Extinction ratio in DR links (comment 298)

Piers Dawe

NVIDIA

Some scope for improvement

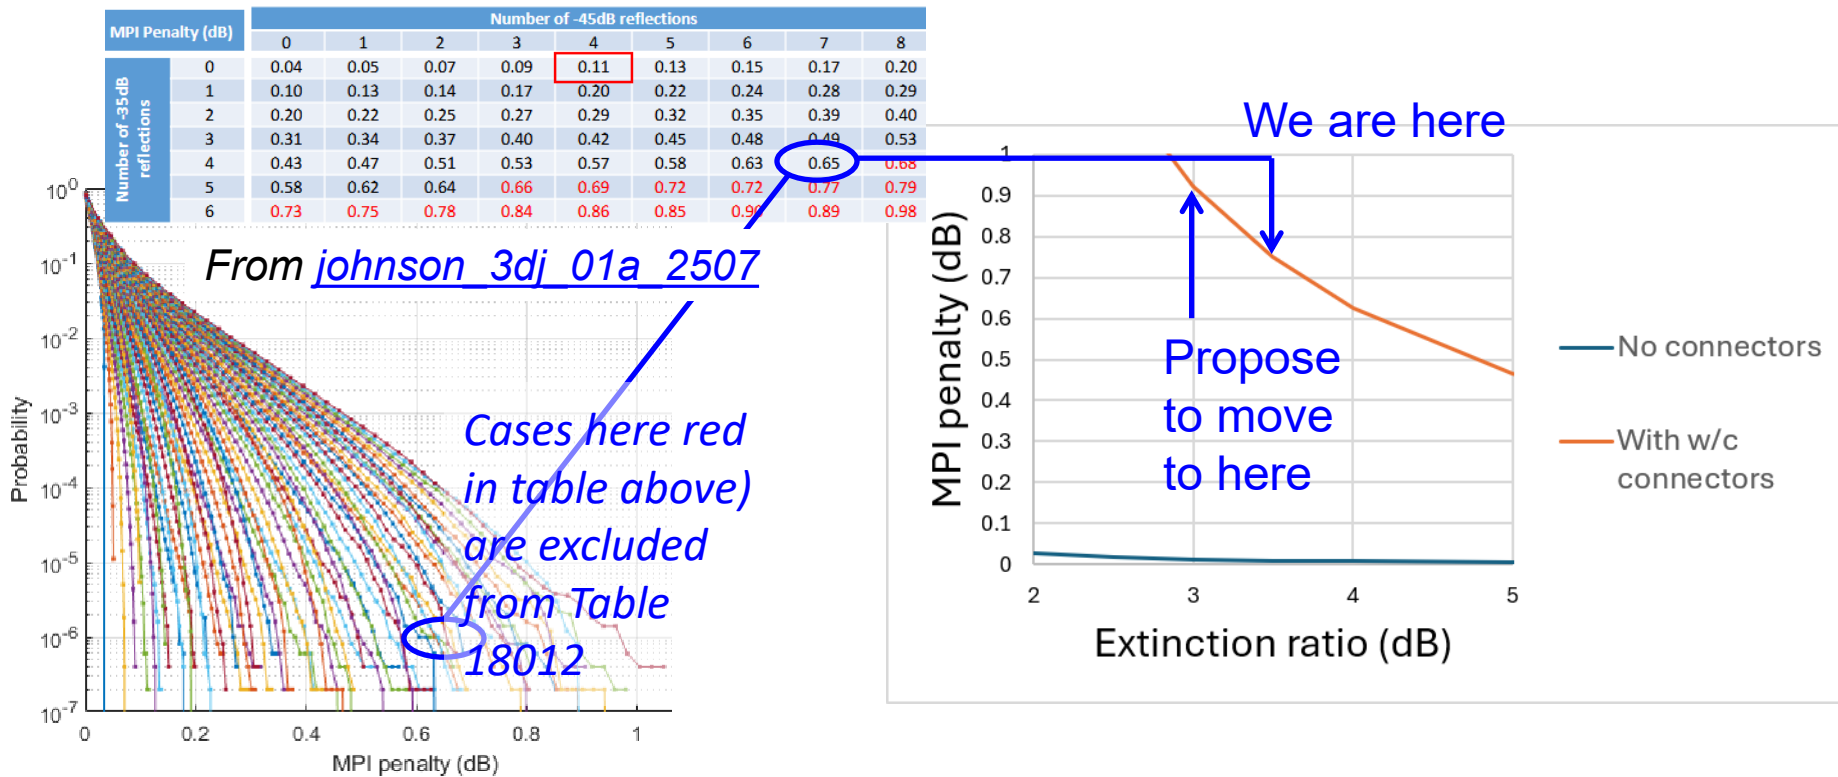
- The 0.1 dB mentioned (actually 0.11 dB per [johnson 3dj 01a 2507](#) applies to a cell where 3 dB loss is allowed
- The worst allowed cell at the bottom of the table represents an MPI penalty of 0.65 dB
- In the next slide it was assumed to be 0.75 dB (as in [anslow 3cd 01 0517](#))

- We can reduce the limit from 3.5 dB to 3 dB for a cost of <0.2 dB
- This is a very good trade for the transmitter
- For the receiver...
